**PREDEVELOPMENT PLAN REVIEW COMMENTS TO APPLICANT**

**Project Number:** PPR2019-00006 **Date:** October 21, 2019

**Project Address:** 444 N. Fair Oaks Avenue & 425 N. Raymond Avenue

**Project Description:** Establishment of a new Planned Development that would allow for the construction of a multi-family project consisting of 206-units

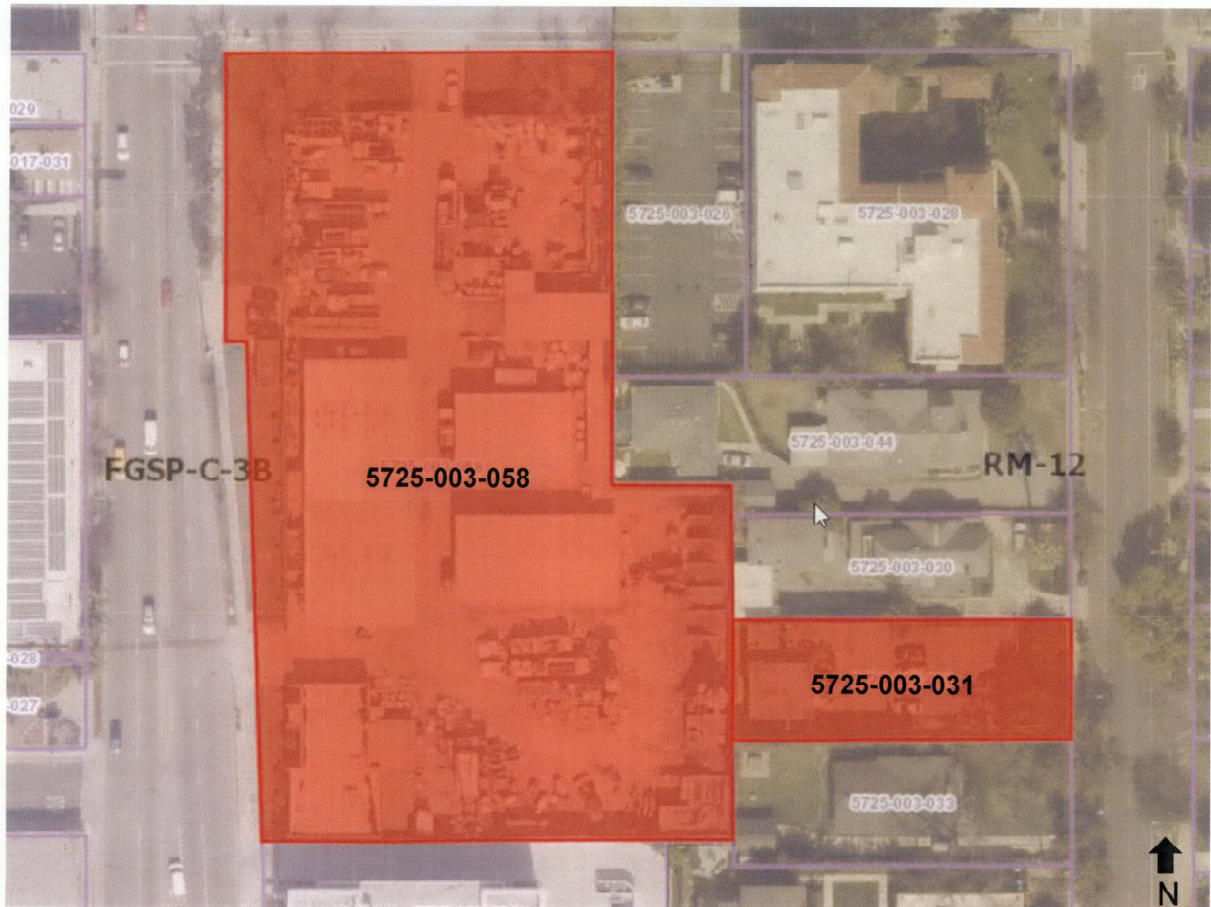
1. **Project Site and Zoning District (PMC §17.22, 17.33):** The project site consists of two separate parcels commonly addressed 444 North Fair Oaks Avenue (5725-003-058) and 425 North Raymond Avenue (5725-003-031). Parcels 5725-003-056 and 5725-003-903 referenced on the plans and application materials are shown deleted by the County Assessor. Parcel 058 is currently zoned FGSP-C-3b (Fair Oaks/Orange Grove Specific Plan - Limited Commercial District 3, Subdistrict “b”) and according to the plan has a site area of 81,035 square feet (1.86 acres). Parcel 031 is zoned RM-12 (Multi-Family Residential, Two Units Per Lot) and according to the plan has a site area of 9,942 square feet (0.23 acres). The aggregate site area per the plan is 90,977 square feet (2.09 acres). These figures differ slightly from the Assessor’s available figures. As part of future submittals a site survey and complete legal information (e.g. chain of title, grant deeds, legal descriptions, etc.) referencing all active parcel numbers shall be provided to verify project site area.
